# HISTORIC AND DESIGN REVIEW COMMISSION

October 06, 2021

**HDRC CASE NO:** 2021-090  
**ADDRESS:** 310 E CAROLINA ST  
**LEGAL DESCRIPTION:** NCB 2956 BLK 0 LOT 17  
**ZONING:** R-6, H  
**CITY COUNCIL DIST.:** 1  
**DISTRICT:** Lavaca Historic District  
**APPLICANT:** Nicholas Melde/Architexas  
**OWNER:** Peter Hermosa/HERMOSA PETER JOSEPH  
**TYPE OF WORK:** Demolition of primary structure, new construction of primary structure and 2-story rear addition  
**APPLICATION RECEIVED:** September 22, 2021  
**60-DAY REVIEW:** Not applicable due to City Council Emergency Orders  
**CASE MANAGER:** Rachel Rettaliata  
**REQUEST:**

Hermosa Residence  
Reconstruction + Addition

Sheet Name  
Existing Elevations

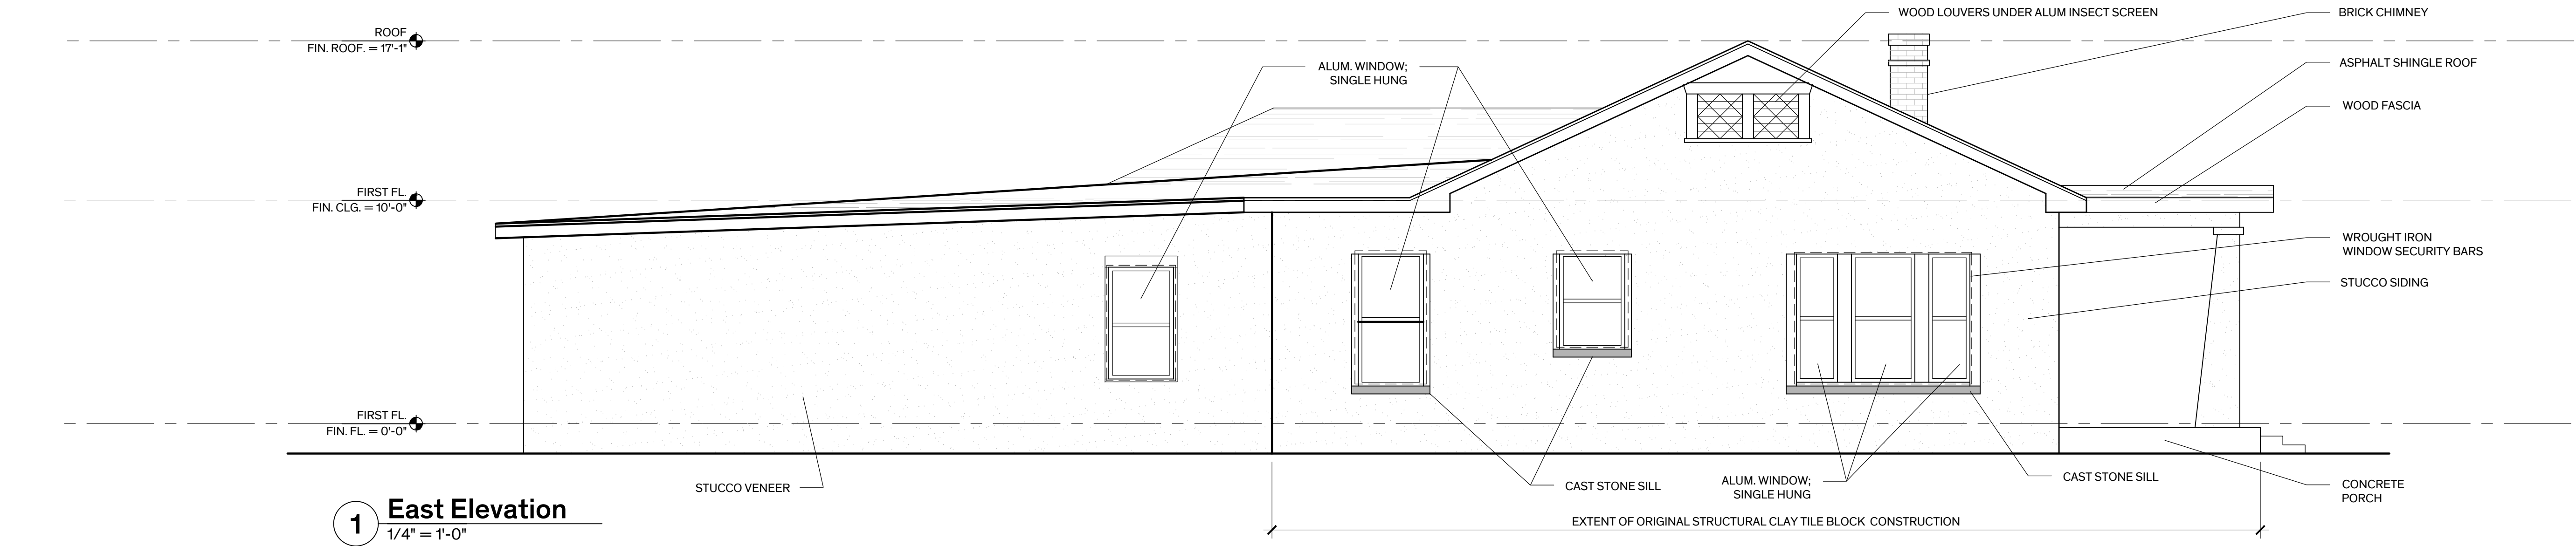
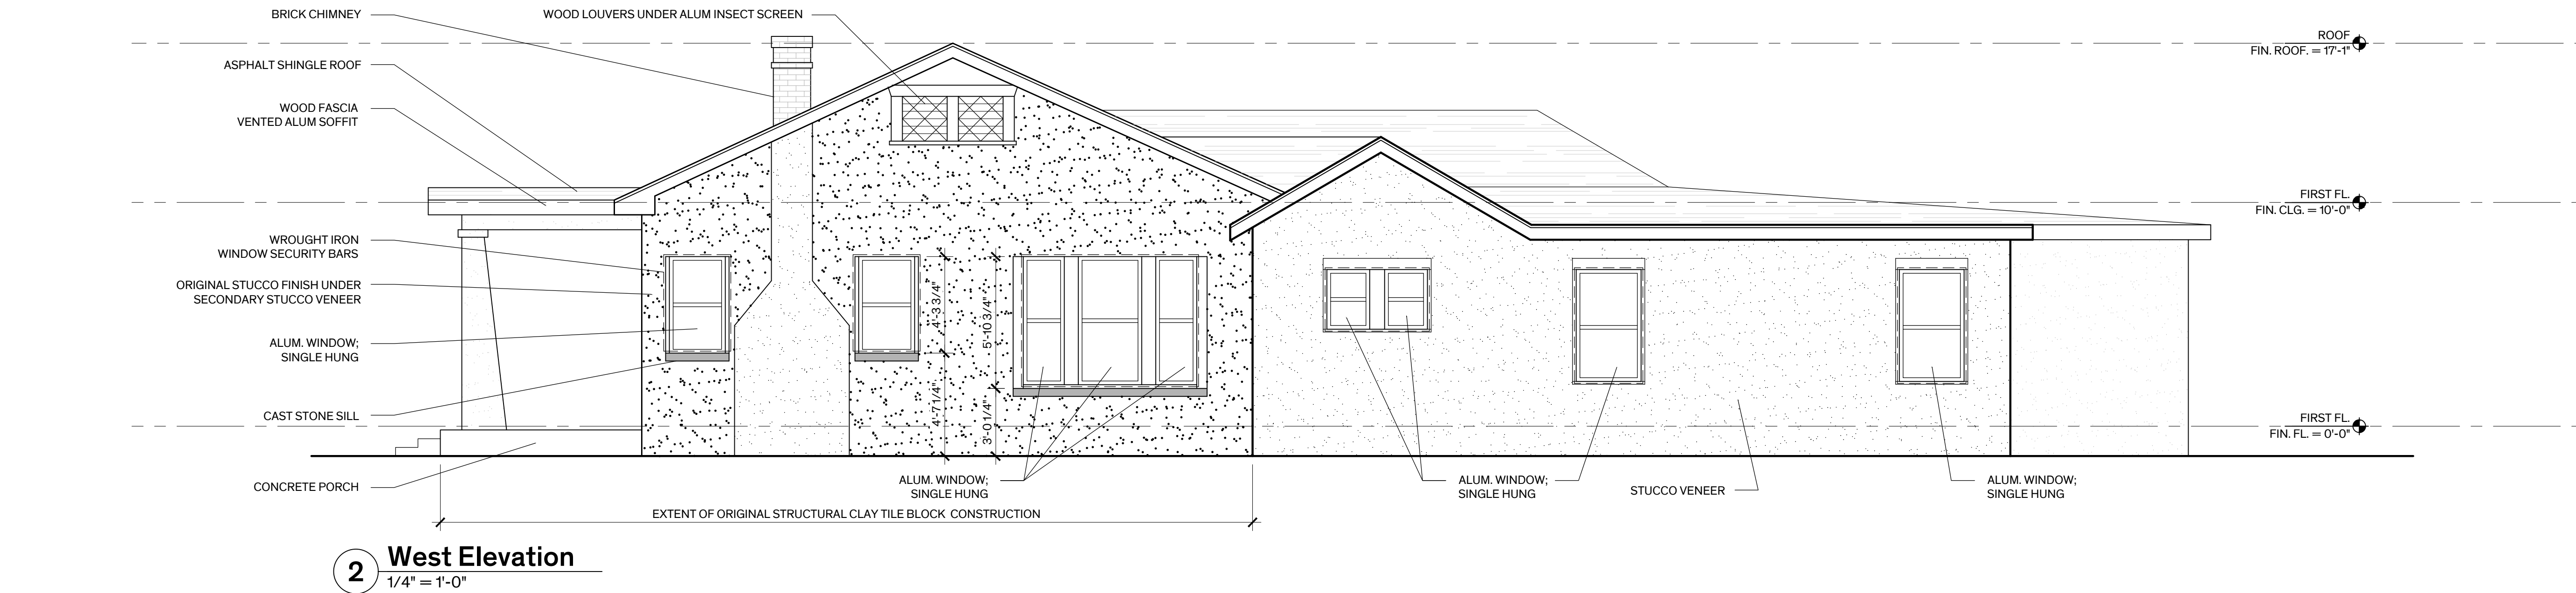
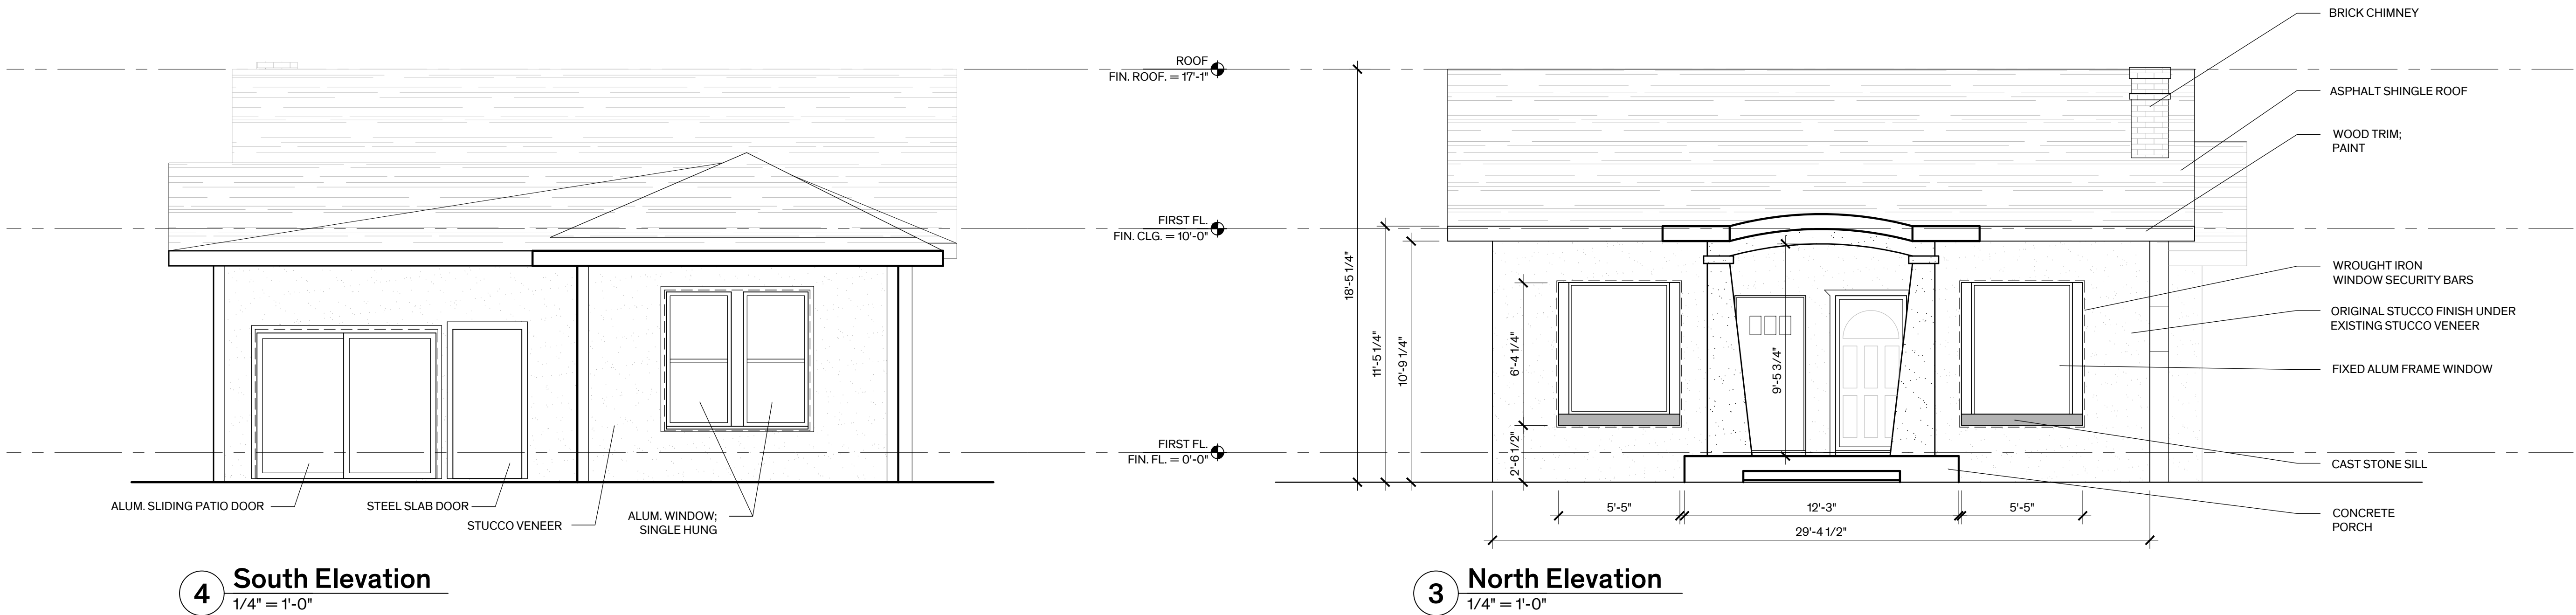
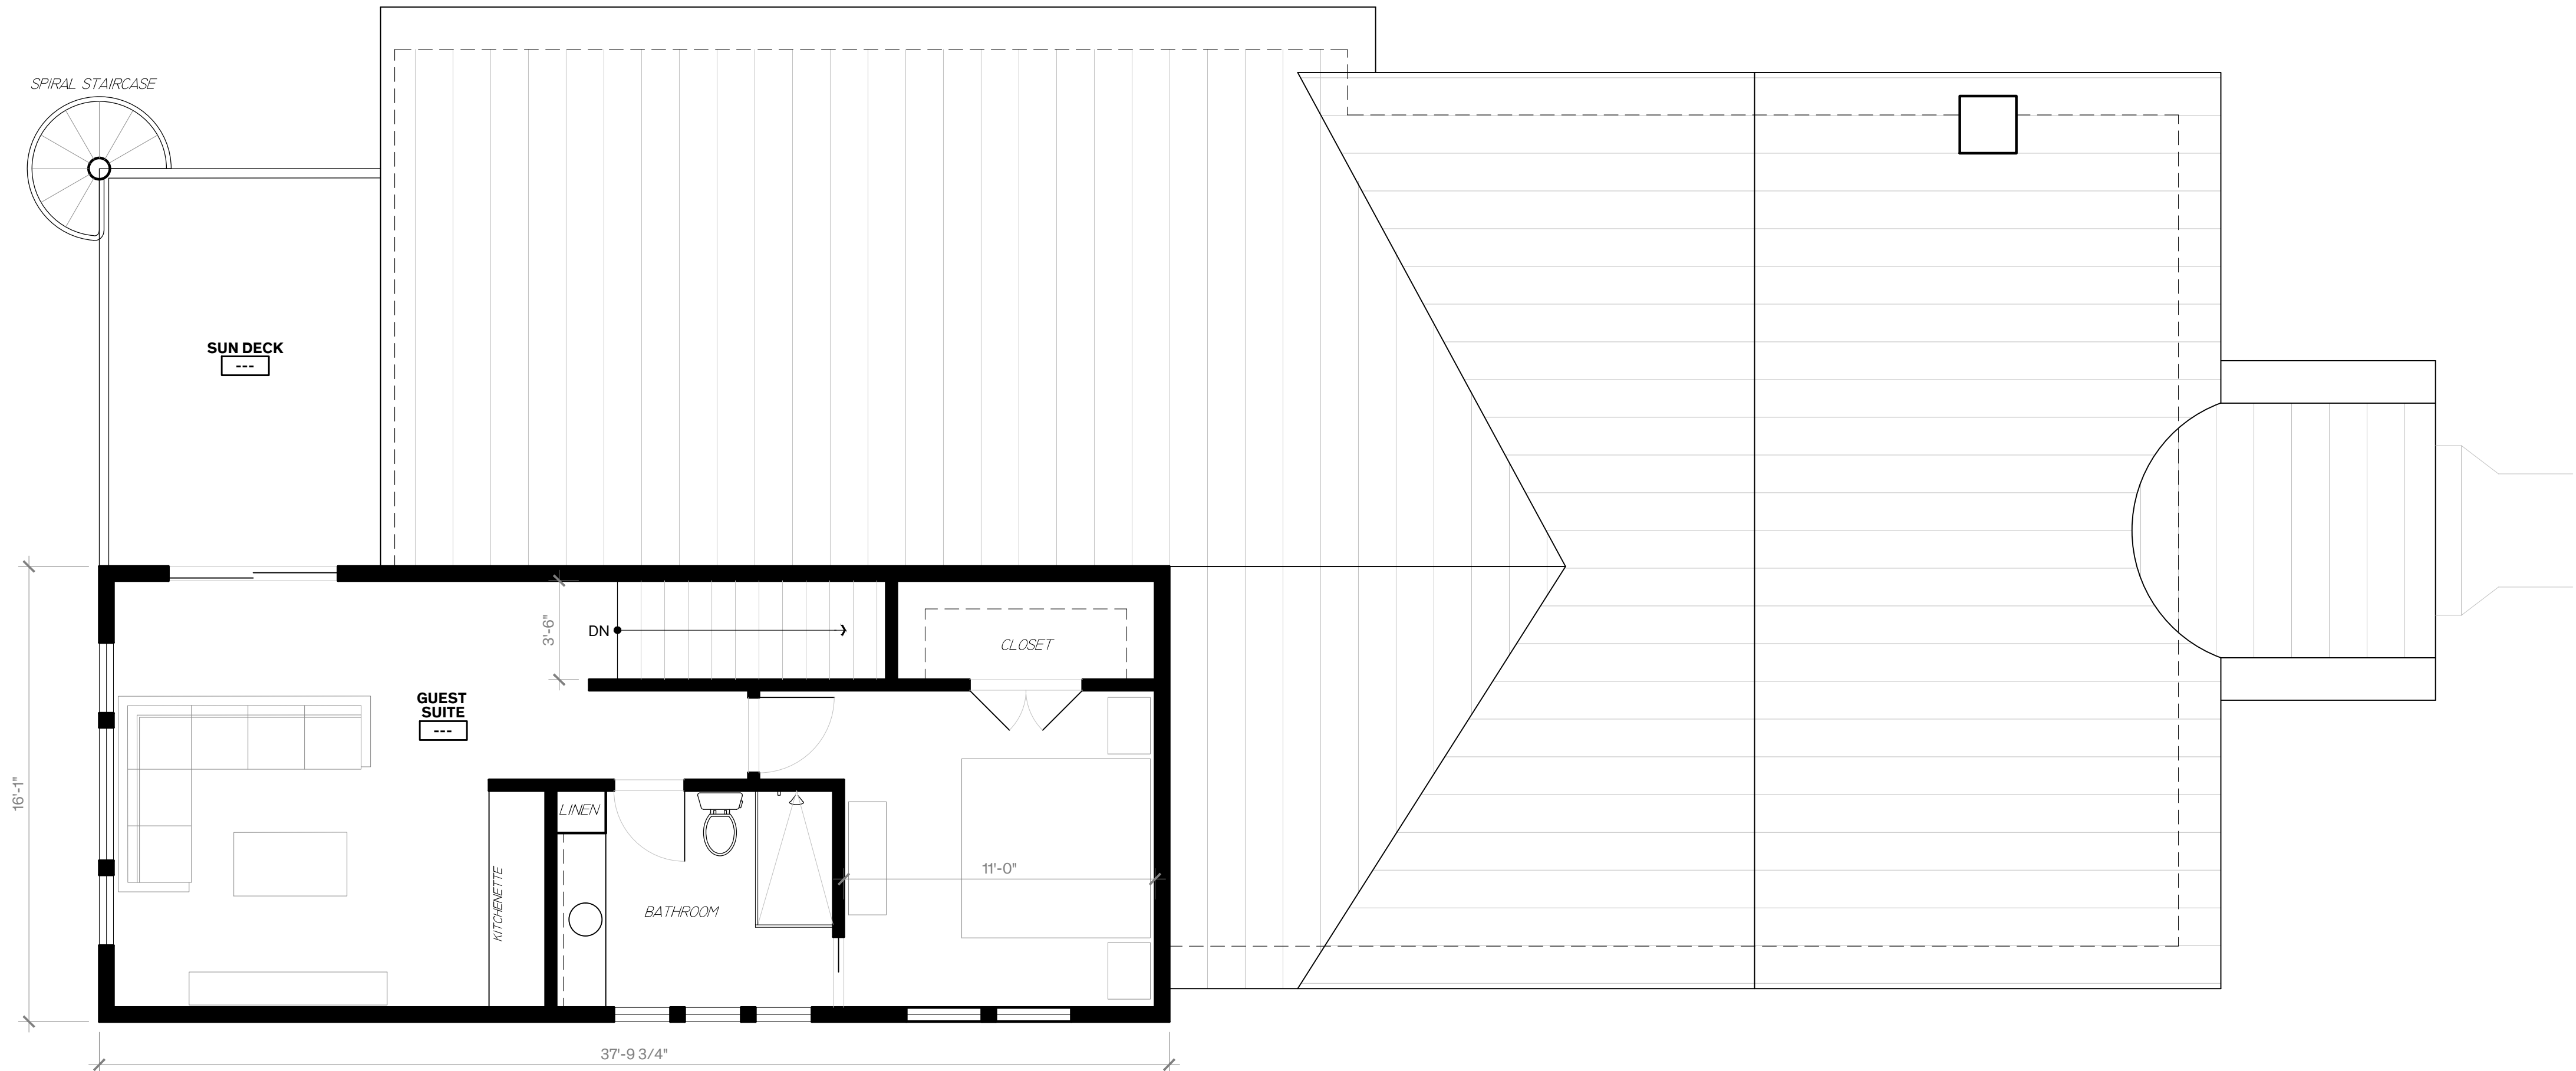
- i. That the applicant submits accurate, as-built elevation drawings for each side of the existing structure and proposed addition to staff for review prior to returning to the HDRC for conceptual approval. ***This stipulation has been met.***

AMR: Show us which walls are masonry?

2 Second Floor Plan  
1/4" = 1'-0"

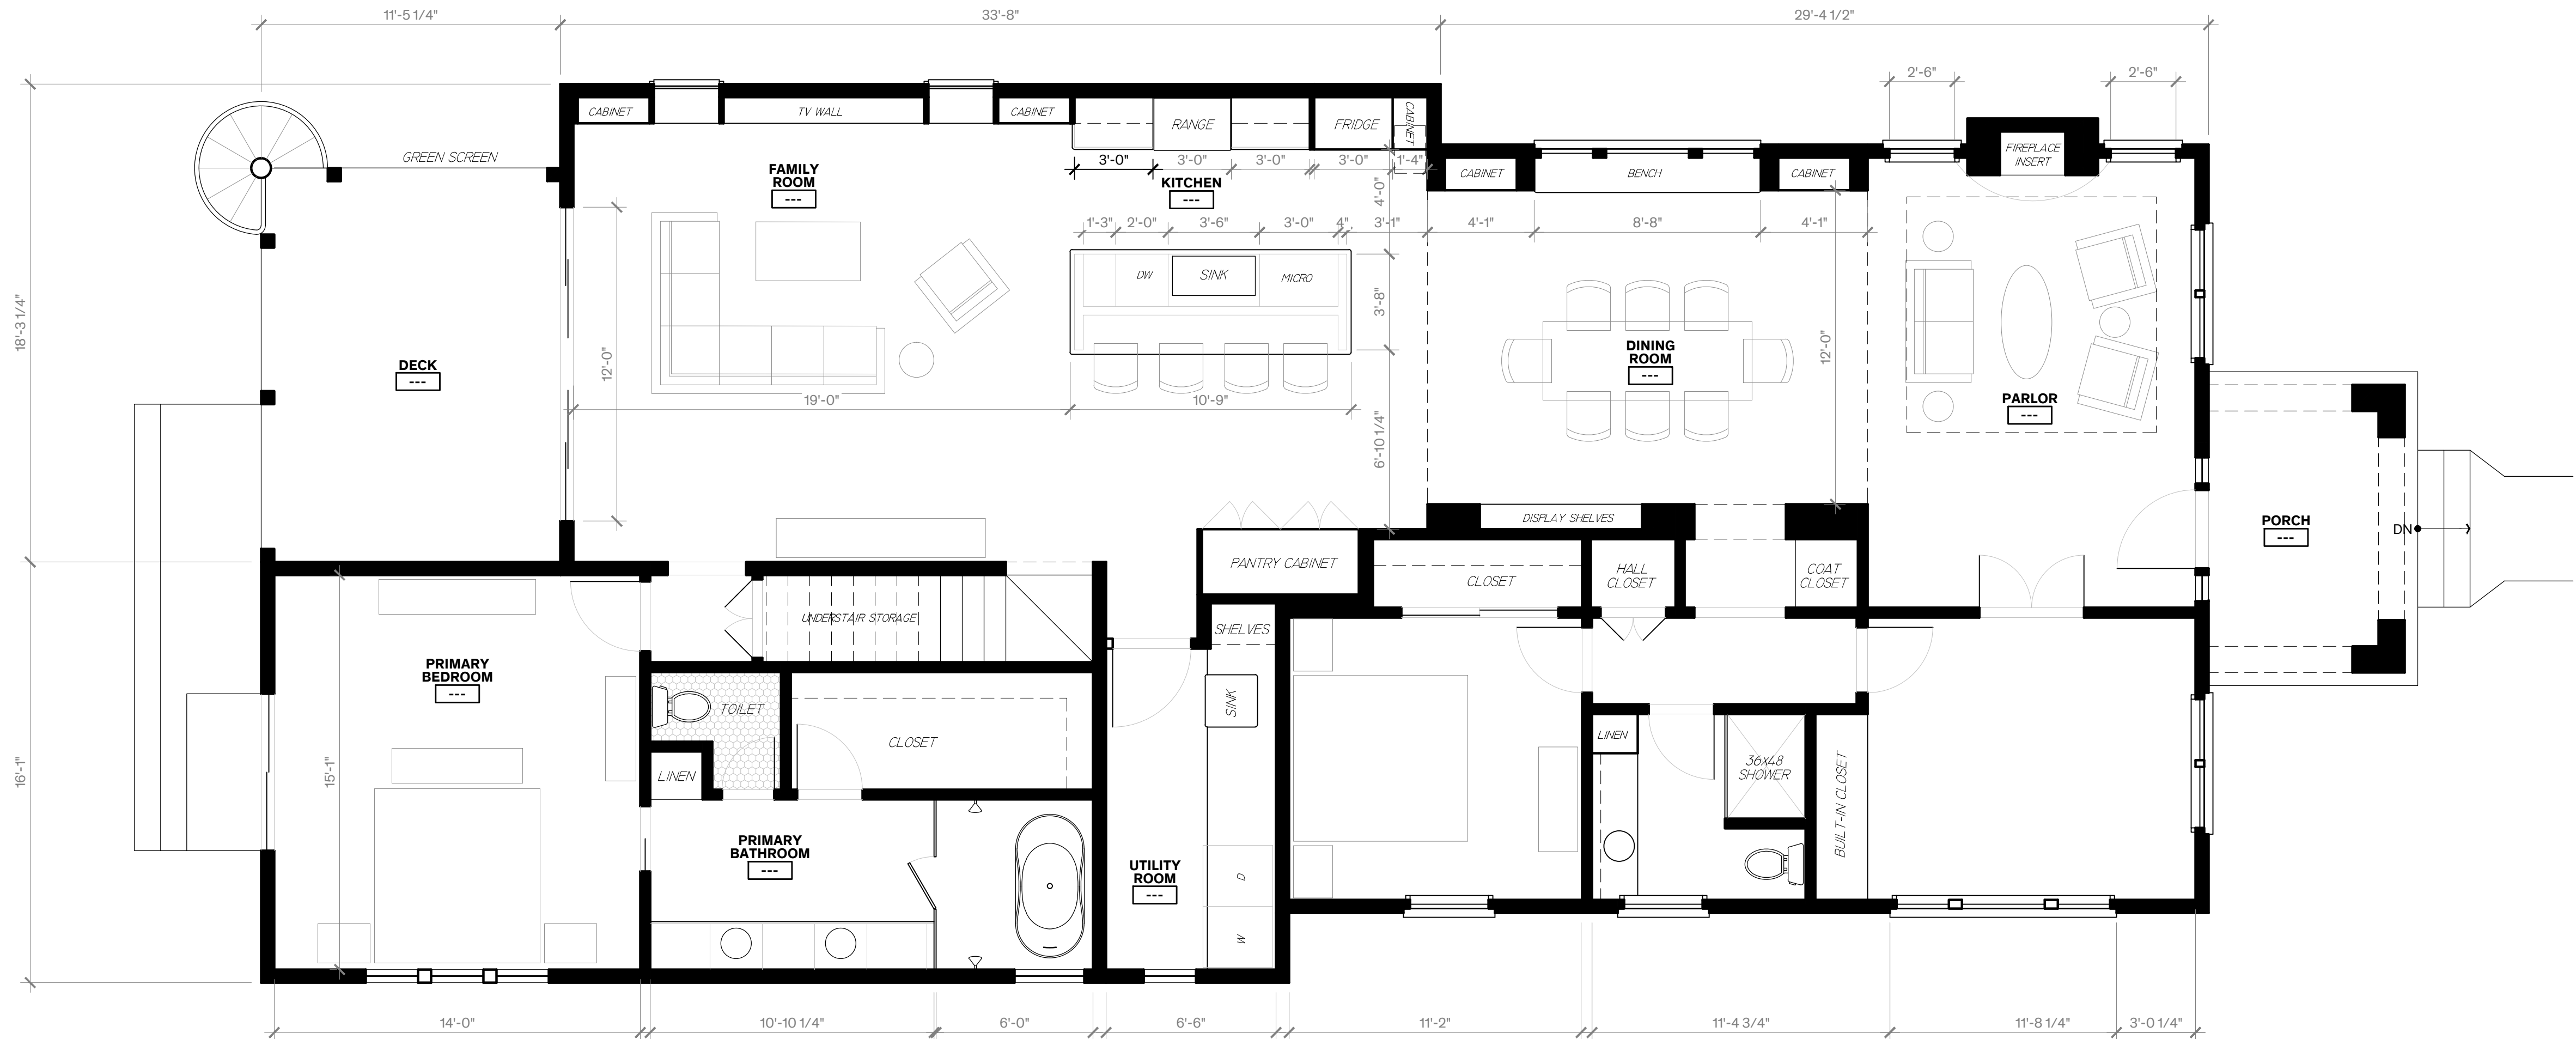
- 2c. **LOT COVERAGE** – The applicant has proposed to construct a 2-story rear addition to the reconstructed primary structure. The applicant has not provided the total percentage of lot coverage for the primary structure and the addition. The applicant should submit the percentage of lot coverage for review. Total lot coverage should not exceed 50 percent.

- 2d. **MASSING AND FOOTPRINT** – The applicant has proposed to construct a 2-story rear addition. Guideline 1.B.i for Additions stipulates that residential additions should be designed to be subordinate to the principle façade of the original structure in terms of scale and mass. Guideline 2.B.iv for Additions states that the building footprint should respond to the size of the lot. An appropriate yard to building ratio should be maintained for consistency within historic districts. Residential additions should not be so large as to double the existing building footprint, regardless of lot size. The proposed addition is 2-stories, which is a full story larger than the primary historic structure. The floor heights of the rear addition allow for the view from the public right-of-way is minimized. The existing structure is approximately 1,938 square feet. The proposed reconstructed structure with the new 2-story rear addition will be approximately 2,289 square feet. The footprint of the original clay tile structure is approximately 1,000 square feet. Staff finds the proposal appropriate.

- 2e. **ROOF** – The applicant has proposed to install a front gable roof form on the 2-story rear addition that will be visible from the public right-of-way. The side of the rear addition facing west will feature a shed roof and second floor balcony at the rear. Only a portion of the front gable roof on the rear addition will be visible from the public right-of-way, over the east side of the front facade. Guideline 1.A.iii for Additions stipulates that residential additions should utilize a similar roof pitch, form, overhang, and orientation as the historic structure. The historic structure features a side gable roof form with a front gable. Staff finds that the applicant should submit a line-of-sight study for review.

- ii. That the applicant submits material specifications to staff for review and approval prior to returning to the HDRC for conceptual approval.
- iii. That the applicant submits window specifications to staff for review. Wood or aluminum-clad wood windows are recommended and should feature an inset of two (2) inches within facades and should feature profiles that are found historically within the immediate vicinity. Meeting rails must be no taller than 1.25” and stiles no wider than 2.25”. White manufacturer’s color is not allowed, and color selection must be presented to staff. There should be a minimum of two inches in depth between the front face of the window trim and the front face of the top window sash. This must be accomplished by recessing the window sufficiently within the opening or with the installation of additional window trim to add thickness. Window trim must feature traditional dimensions and architecturally appropriate sill detail. Window track components must be painted to match the window trim or concealed by a wood window screen set within the opening.

- iv. That the applicant submits a line-of-site study for the proposed rear addition.
